MULTNOMAH COUNTY BUILDING DEPARTMENT
PLAN CHECK SHEET

Job Name: 1638 NE 102nd
Location: 1638 NE 102nd
Date: 6-23-65 Checked By: Jorge

SCALE SECTION - PAINT BATH 1/8" = 1'-0"	GATEWAY MOTORS BODY SHOP BUILDING	ELEVATIONS DETAILS	DRAWN BY W.S. STORCH DATE MAY 12, 1988 CHECKED BY W.S. STORCH DATE MAY 12, 1988	WERNER S. STORCH & ASSOCIATES CONSULTING ENGINEERS 340 FIRST ST., LAKE OSWEGO, OREGON 97031 503-235-1234 1233 MISSION ST. SE, SALEM, OREGON 97302 503-325-1300
--	--------------------------------------	-----------------------	--	---

SECTION THRU STAIRS

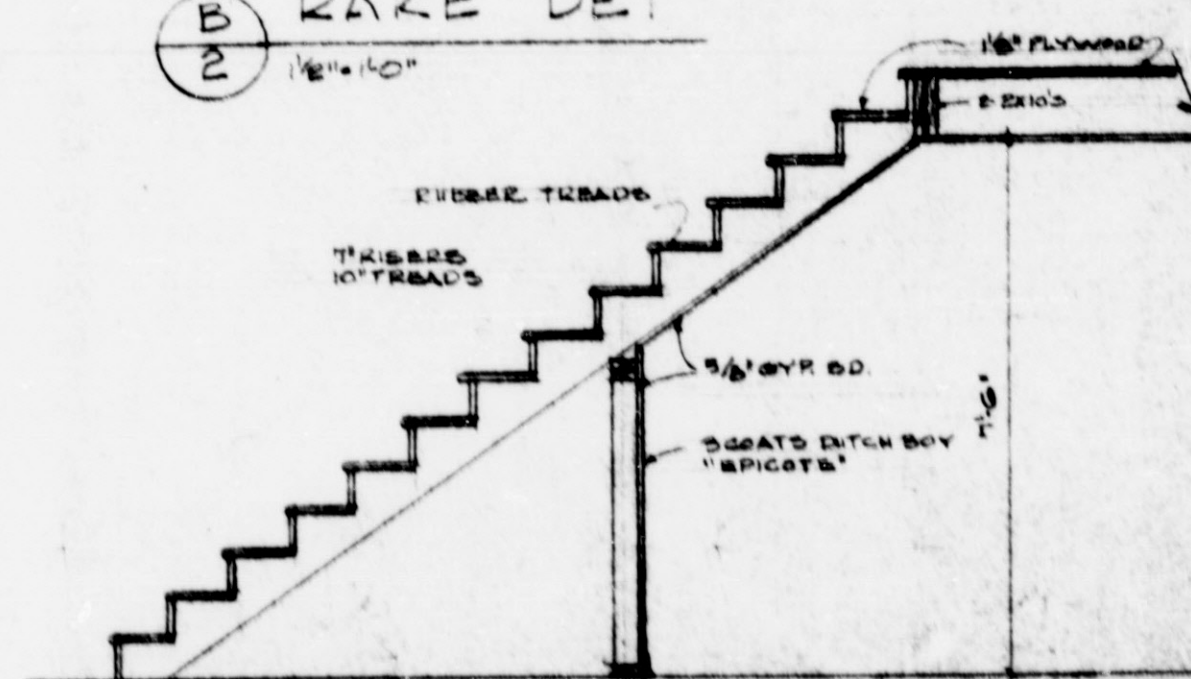
1. Provide stairs w/ hand rail 3319
2. Provide stairs w/ hand rail 3319
3. Provide stairs w/ hand rail 3319
